Inspection Date: **17-Nov-2024**

Report Number: **QCR-MC1759**

Manufacturer: MOCO	Brand: MCo	Model Number: MCo Target Display -LIPS WEDGES
---------------------------	-------------------	--

Photo of improvements for the tray loosed

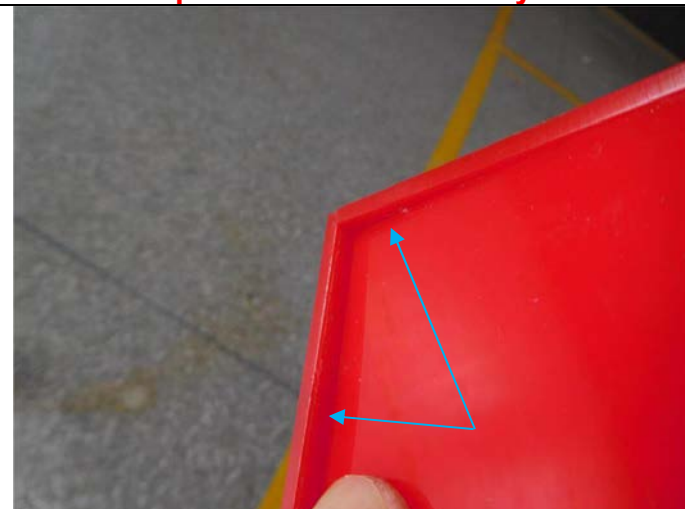
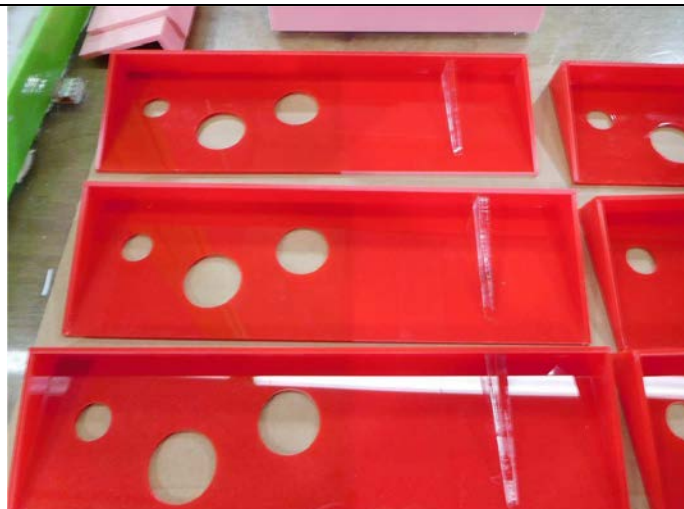
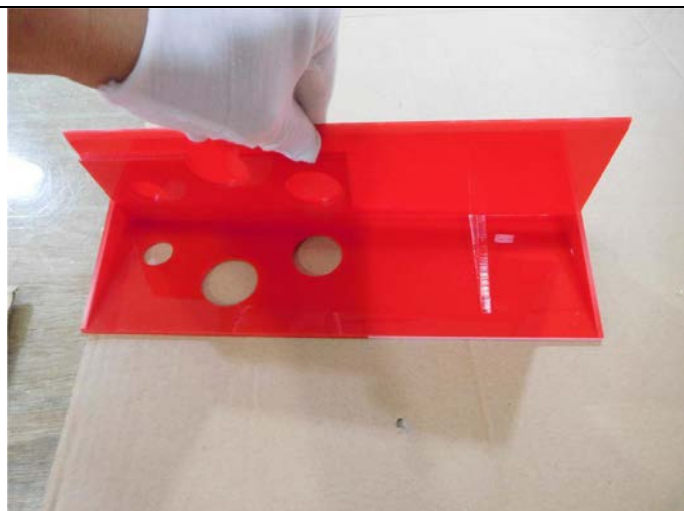
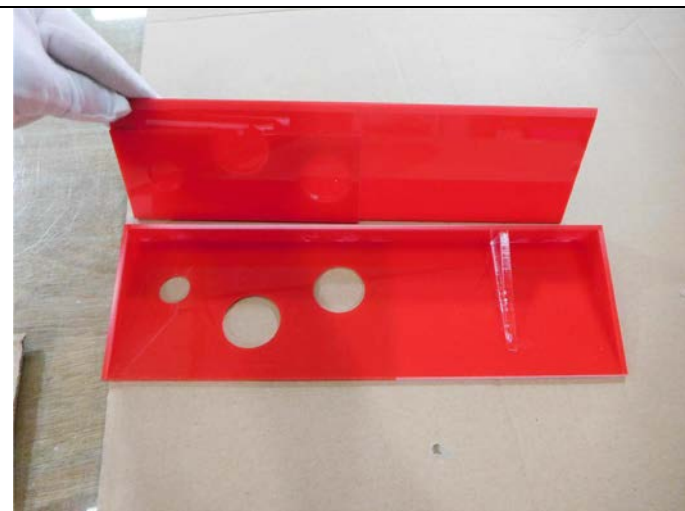
As for the problem that the bottom plate of the tray is not firmly bonded and easy to loose, the factory has made improvements to this problem. This improvement is to add support ribs inside the tray to obtain more bearing area and glue bonding points. Please refer to page 2 for details:

This improvement is to add support ribs inside the tray to obtain more bearing area and glue bonding points.
